YANG module ieee802-dot1dj-tsn-config-uni

This contribution details multiple [ballot comments](#) and their respective [proposed changes](#) regarding the YANG module [ieee802-dot1dj-tsn-config-uni](#)

YANG Containers & RPCs

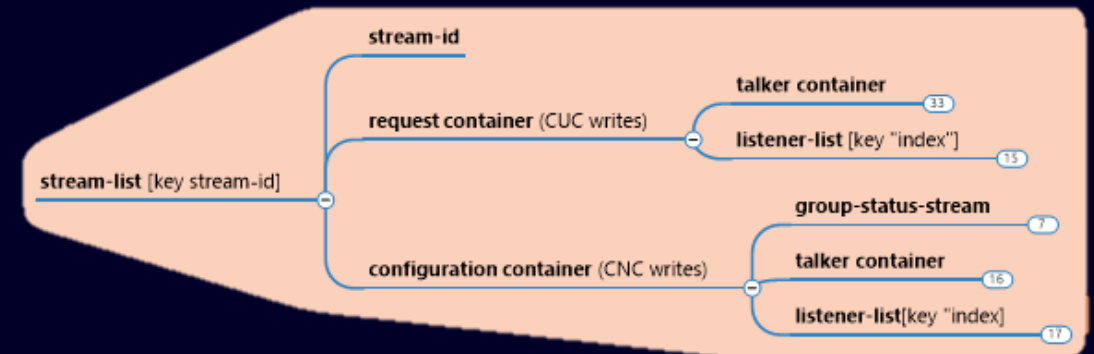
A hierarchical data model would fit better for the required access control.

- Domain[1..n]
 - Client[1..k] -> NACM (write access limited to "this" client)
 - Stream [1...l]
- Root access to the stream list only via RPC

Stream requests: RPC AddStreams

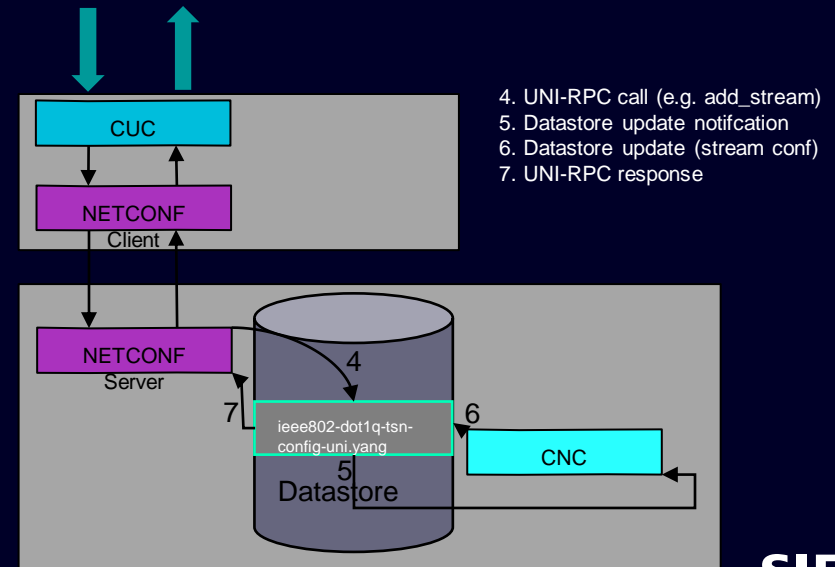
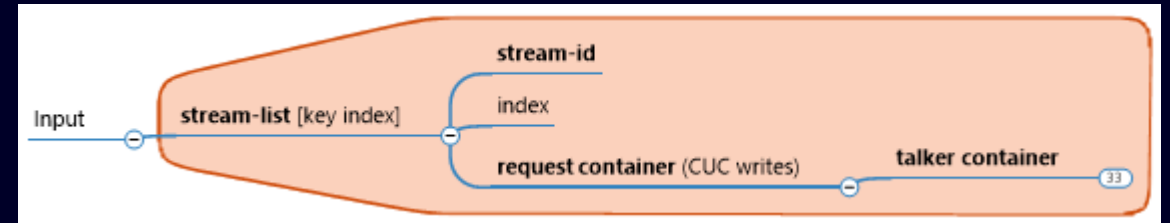
- Description
 - Adds multiple streams to CNC datastore
 - Assigns StreamIDs to streams
- Input (list of (StreamID, request container))
where StreamID := unknown (optional?)
- Output (list of (StreamID))
where StreamID assigned by CNC
- CUC calls RPC
- RPC notifies CNC of new AddStream request
- CNC assigns StreamIDs to these streams
- RPC stores stream with StreamIDs in YANG container
- RPC responses with list of assigned StreamIDs sent to CUC

Stream requests: RPC ScheduleStreams

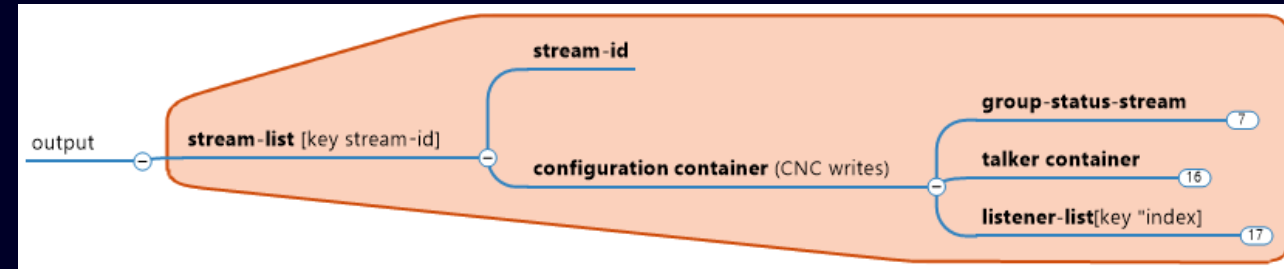
- Description
 - Schedules/ plans multiple streams
- Input (list of (StreamID))
- Output (stream list)
 - Modified configuration containers after scheduling/ planning requested streams
 - Stream dst-MAC addr assigned by CNC (configuration container)
 - Configuration information (relevant to CUC and talker) of streams impacted by requested streams

Scheduling multiple streams in one request is an IA requirement (bidirectional communication)

15 **46.2.5.3.1 IEEE802-MacAddresses**

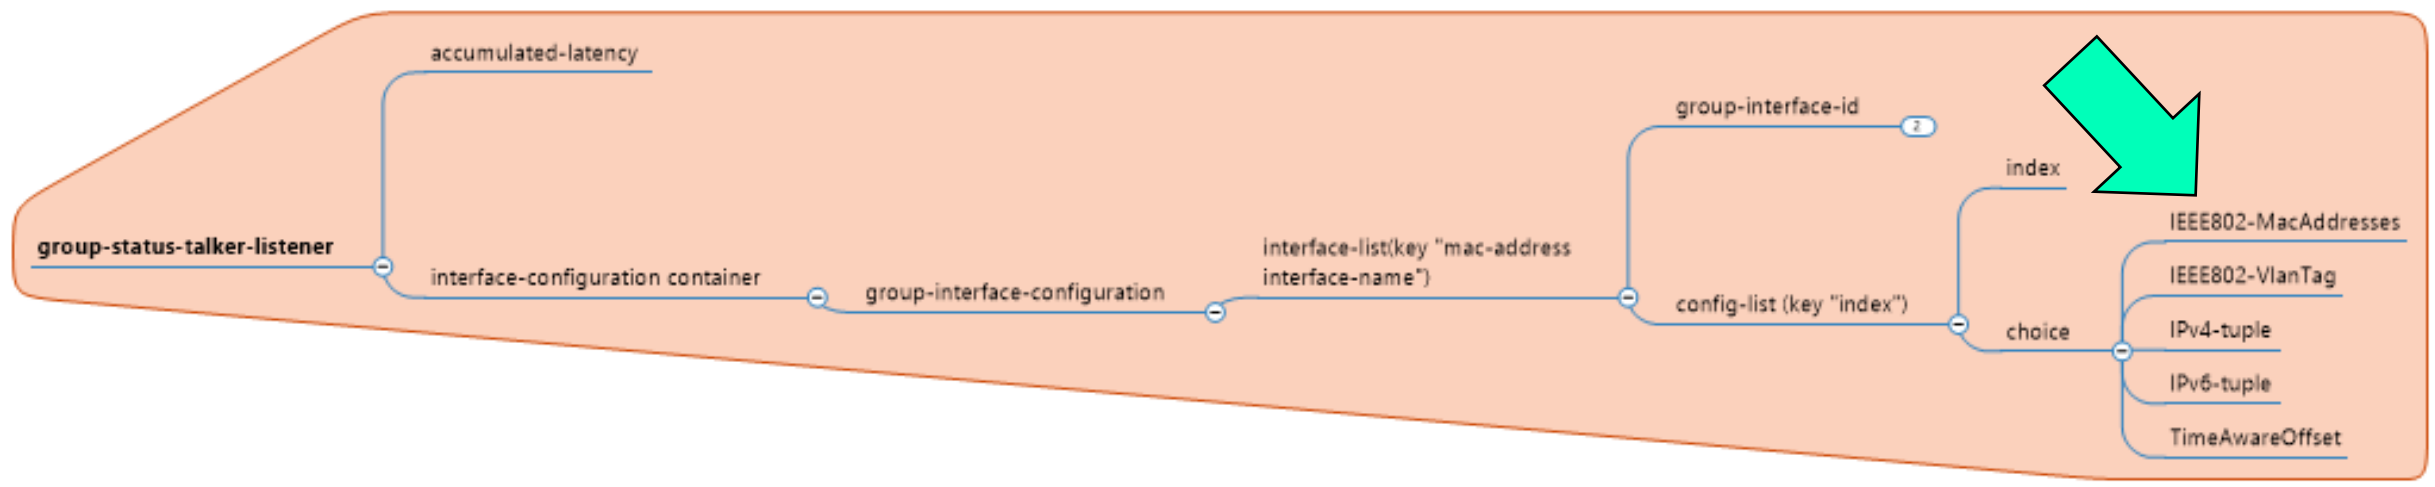
22 This configuration value is not provided unless IEEE Std 802.1CB is supported and a value for Active
23 Destination MAC and VLAN Stream identification is provided in CB-StreamIdenTypeList of
24 InterfaceCapabilities.

This restriction must be removed from the standard

Stream requests: RPC AddAndScheduleStreams

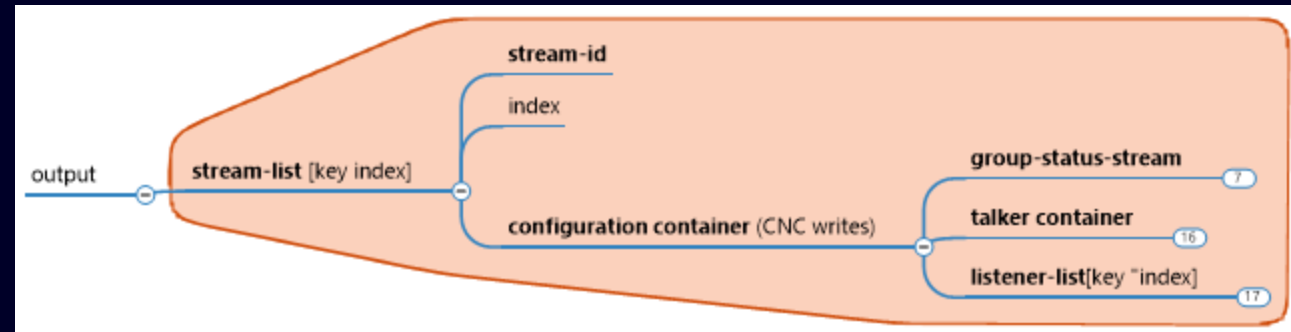
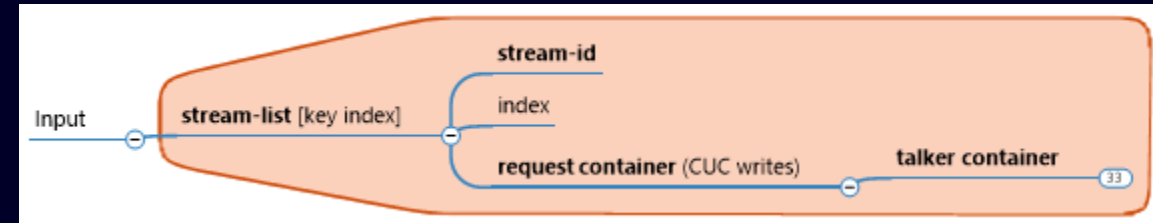
- Description
 - Adds multiple streams to CNC datastore
 - Assigns StreamIDs to streams
 - Schedules multiple streams
 - Input (list of (StreamID, request container))
where StreamID := unknown (optional?)
 - Output (stream list)
 - Modified configuration containers after scheduling/ planning requested streams
 - StreamID assigned by CNC
 - Stream dst-MAC addr assigned by CNC
 - Configuration information (relevant to CUC and talker) of streams impacted by requested streams

**Scheduling multiple streams
in one request is an IA requirement
(bidirectional communication)**
